<p>To: Mercedes-Benz Dealers, General Managers, Sales Managers, Service Managers, Parts Managers</p>	<p>From: Anthony Washington, Senior Manager, Regulations and Certifications</p>
<p>Re: Service Campaign Notification Model: Metris Model Year: 2021 Replace Longitudinal Member Weld Nuts</p>	<p>Date: February 2025</p>

Campaign No.:	Campaign Desc.:	NHTSA ID:	Replace Longitudinal Member Weld Nuts
2025020011	VS2SPANBA	N/A	
This is to notify you of a Service Campaign to replace weld nuts on the longitudinal member on 1 MY 2021 Metris Van. All affected VINs will be flagged as "OPEN" in VMI			
Background			
Issue	Mercedes-Benz AG, the manufacturer of Mercedes-Benz Metris Vans, has determined that the weld nuts on the longitudinal member were not installed according to current production specifications.		
What We're Doing	MBUSA is conducting a service campaign. An authorized Mercedes-Benz dealer will replace and install new weld nuts on the longitudinal member.		
Parts	Part is available.		
Vehicles Affected			
Model Year(s)	2021		
Vehicle Model	Metris		
Vehicle Populations			
Total Vehicles	1		
Dealer Inventory	0		
Next Steps/Notes			
AOMS/SOMS	Please ensure your dealers have read and unde

S61.10-A098-79

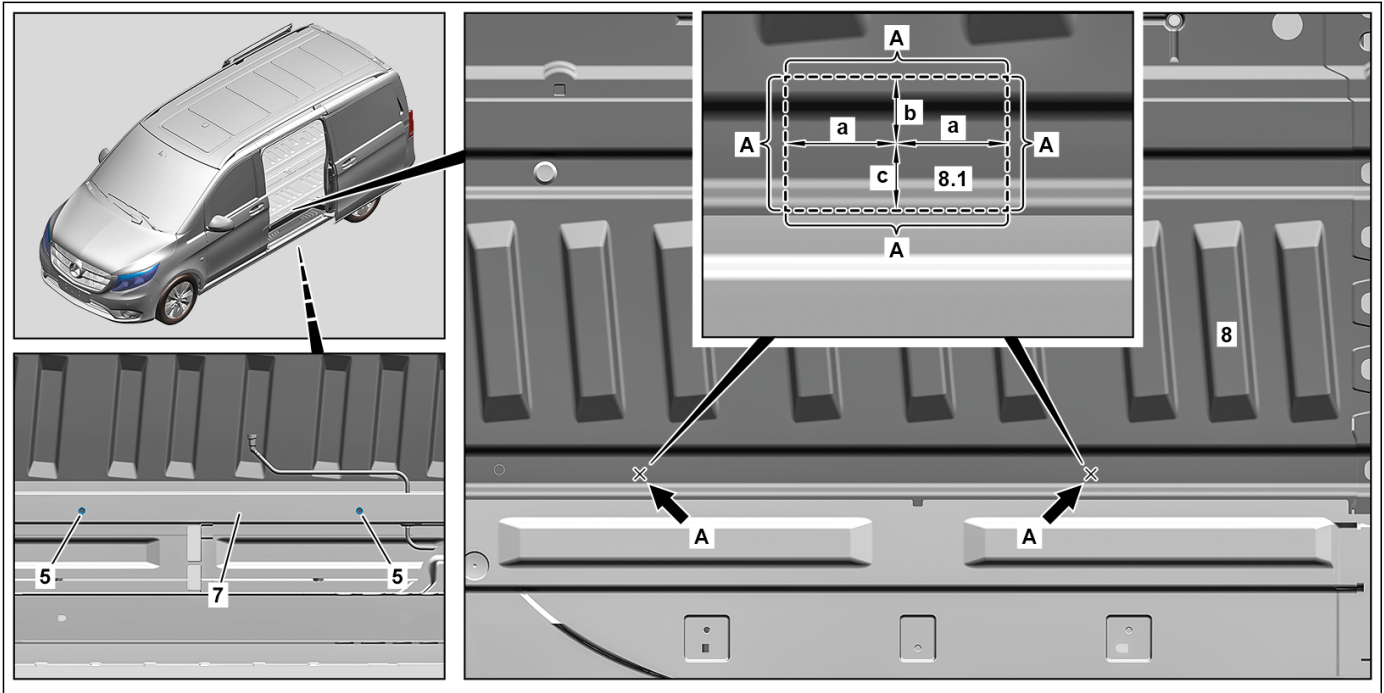
4	Check whether thread of respective weld nut (5) and screw (4) on rear retaining bracket (2) and front retaining bracket (3) is damaged.	<p>ⓘ When checking the respective weld nut (5), it must not be possible to unscrew the screws (4) sluggishly and there must not be any visible damage to the thread. If one of the screws (4) unscrews sluggishly or if there is visible damage to the thread, replace respective weld nut (5) and screw (4). Otherwise, the correct torque of the respective screws (4) cannot be guaranteed.</p> <p>ⓘ At least one of the four following weld nuts (5) is damaged and must be replaced. Otherwise, correct mounting of the rear retaining bracket (2) or front retaining bracket (3) cannot be guaranteed.</p> <p>ⓘ To do so, unscrew screws (4) from rear retaining bracket (2) and front retaining bracket (3). If the screw (4) can be unscrewed sluggishly or if there is visible damage to the thread,</p> <p style="text-align: center;">↓</p> <p>replace respective damaged weld nut (5) with corresponding screw (4); to do so, continue with operation step 5.</p> <p>If it is not possible to determine whether the screw (4) can be unscrewed sluggishly or if there is any damage to the thread without error,</p> <p style="text-align: center;">↓</p> <p>replace all weld nuts (5) with corresponding screws (4); to do so, continue with operation step 5.</p>

S61.10-A100-79

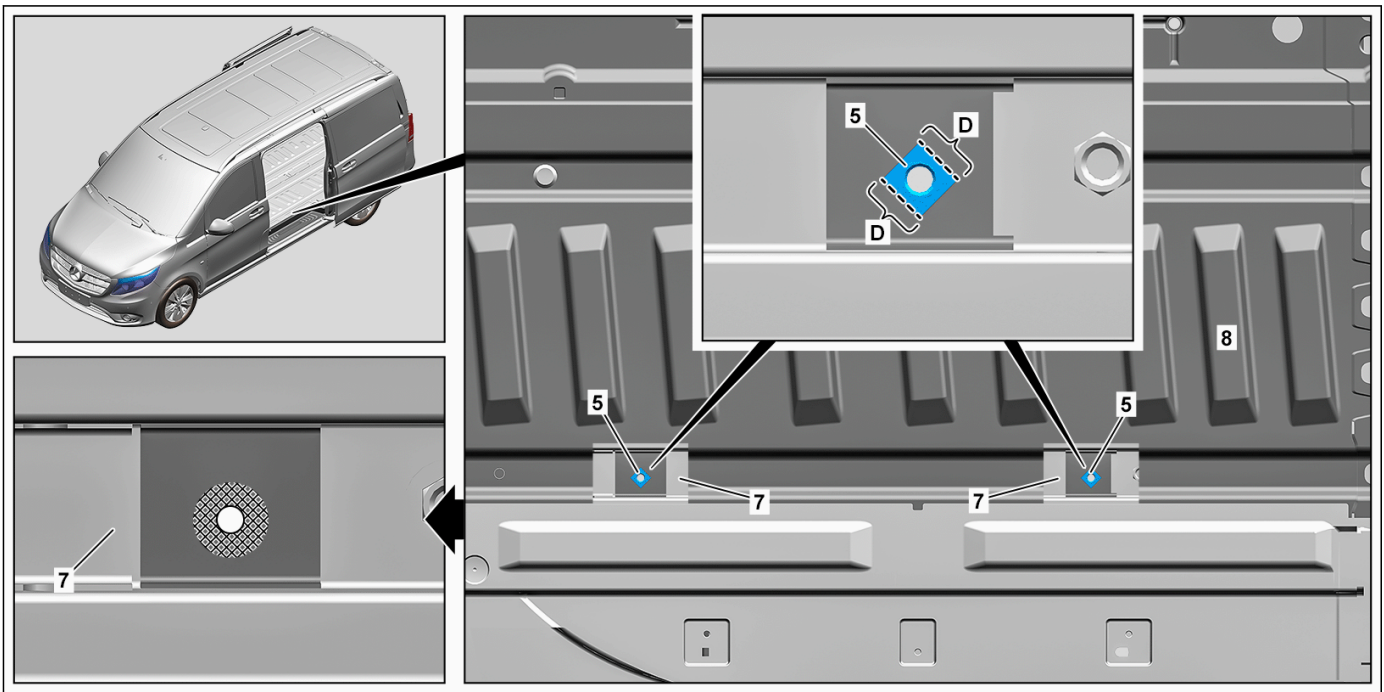
9	Mark separating points on center floor (8) for respective center floor section (8.1) (areas A).	<p>If respective weld nut (5) in longitudinal member (7) has to be replaced.</p> <p>i To do so, mark center point (arrow A) of respective center floor section (8.1) through screw hole of weld nut (5) using a suitable tool from underside of longitudinal member (7).</p> <p>i Observe dimensions (a, b, c).</p>	
10	Separate separating points on center floor (8) for respective center floor section (8.1) (areas A).	<p>If respective weld nut (5) in longitudinal member (7) has to be replaced.</p> <p>!</p> <p>Only cut through one sheet thickness. Otherwise the components below can be damaged and weakened.</p> <p>i This enables access to the respective weld nut (5) in the longitudinal member (7).</p>	
11	Grind mating surfaces on respective center floor section (8.1) and center floor (8) down to bare metal in cross-hatched areas.	<p>If respective weld nut (5) in longitudinal member (7) has to be replaced.</p> <p>i Remove grinding dust and wood shavings.</p>

S61.10-A104-79

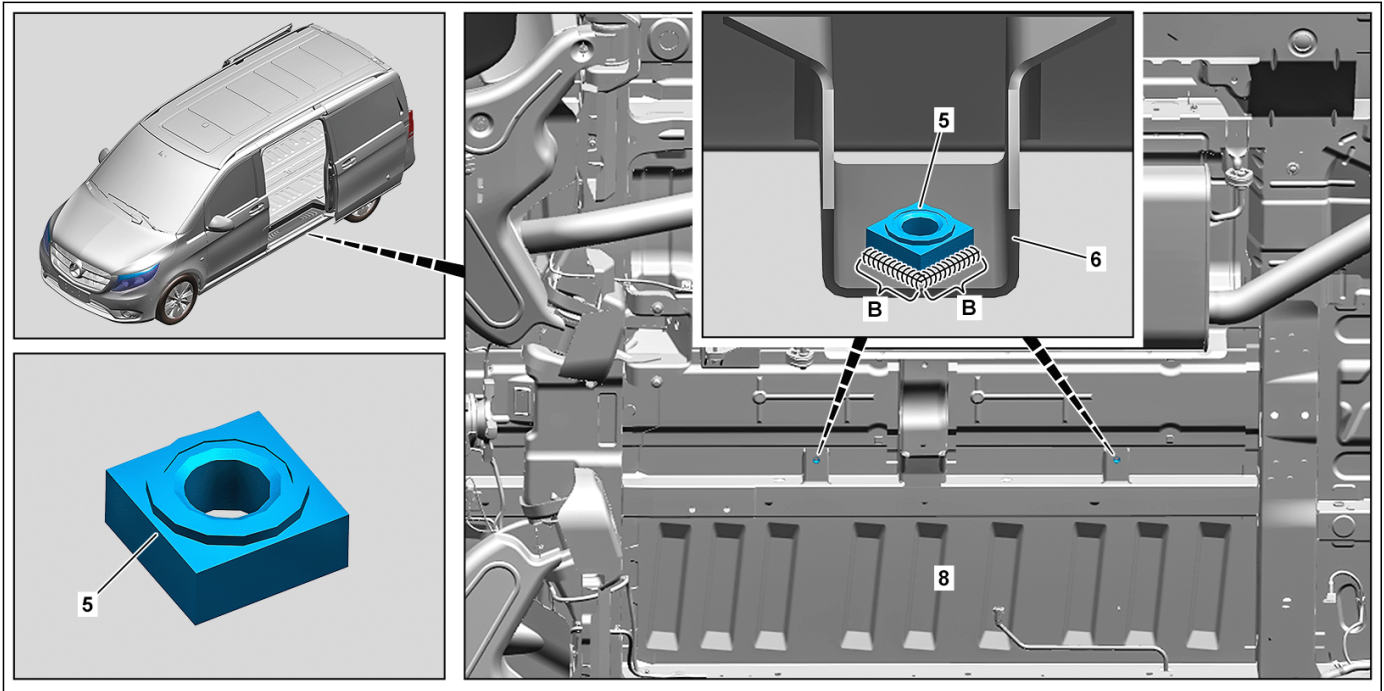
12	Separate respective damaged weld nut (5) from holder for retaining bracket (6) (areas D).	<p>If respective weld nut (5) on holder for retaining bracket (6) has to be replaced.</p> <p>i To do so, release respective damaged weld nut (5) from holder for retaining bracket (6) on weld joints.</p> <p>i Dispose of removed weld nut (5) properly. To do so, observe the applicable legal requirements and specifications of the relevant country.</p>	
13	Separate respective damaged weld nut (5) in longitudinal member (7) (areas D).	<p>If respective weld nut (5) in longitudinal member (7) has to be replaced.</p> <p>i To do so, release respective damaged weld nut (5) from longitudinal member (7) at weld joints.</p> <p>i Dispose of removed weld nut (5) properly. To do so, observe the applicable legal requirements and specifications of the relevant country.</p>	
14	<p>Install and weld in respective new weld nut (5) at holder for retaining bracket (6) (areas B).</p> <p>WS 000 588 02 84 00 Welder</p>	<p>If respective weld nut (5) on holder for retaining bracket (6) has to be replaced.</p> <p>i Order required new weld nut (5) with "DIN 928-M10-ST" specification from free market.</p> <p>i To do so, fasten respective new weld nut (5) at holder for retaining bracket (6) using screw (4).</p>	WS60.00-P-0022K

S61.10-A101-79

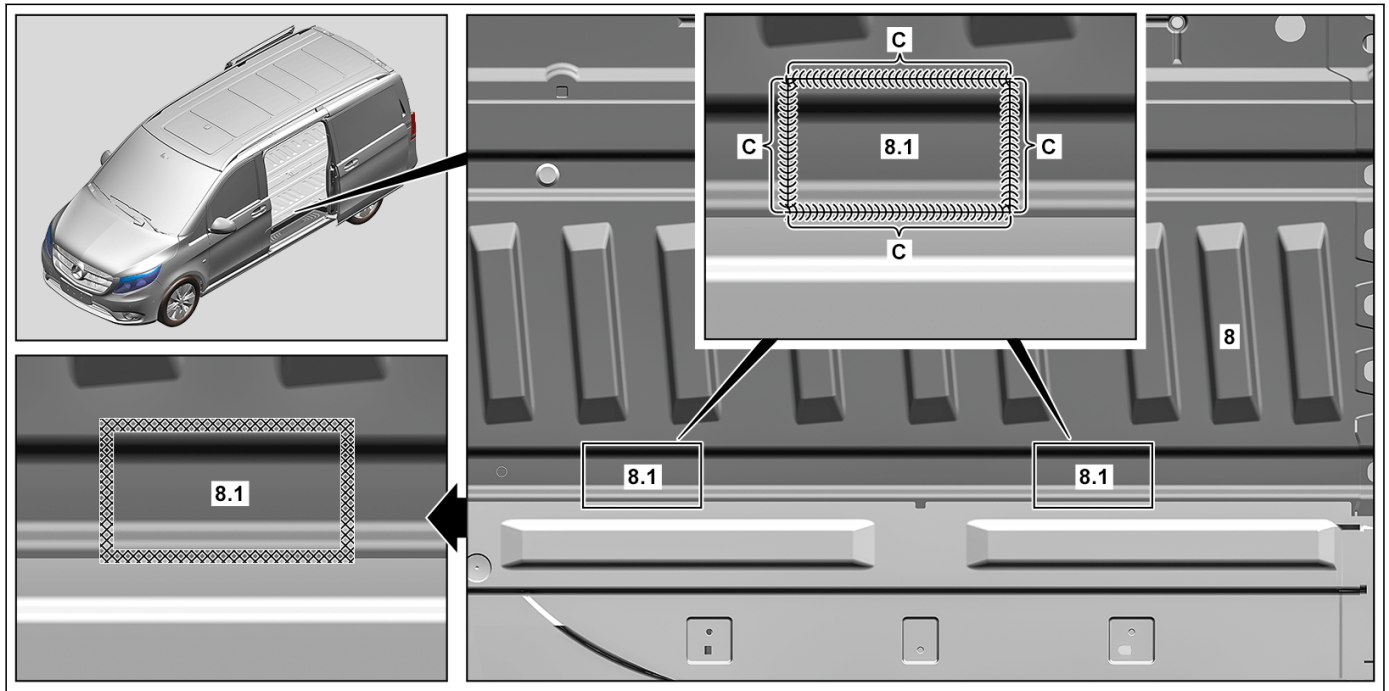
15	<p>Install and weld in respective new weld nut (5) in longitudinal member (7) (areas B).</p> <p>WS 000 588 02 84 00 Welder</p>	<p>If respective weld nut (5) in longitudinal member (7) has to be replaced.</p> <p>i Order required new weld nut (5) with "DIN 928-M10-ST" specification from free market.</p> <p>i To do so, fasten respective new weld nut (5) at screw hole of longitudinal member (7) using screw (4).</p>	WS60.00-P-0022K
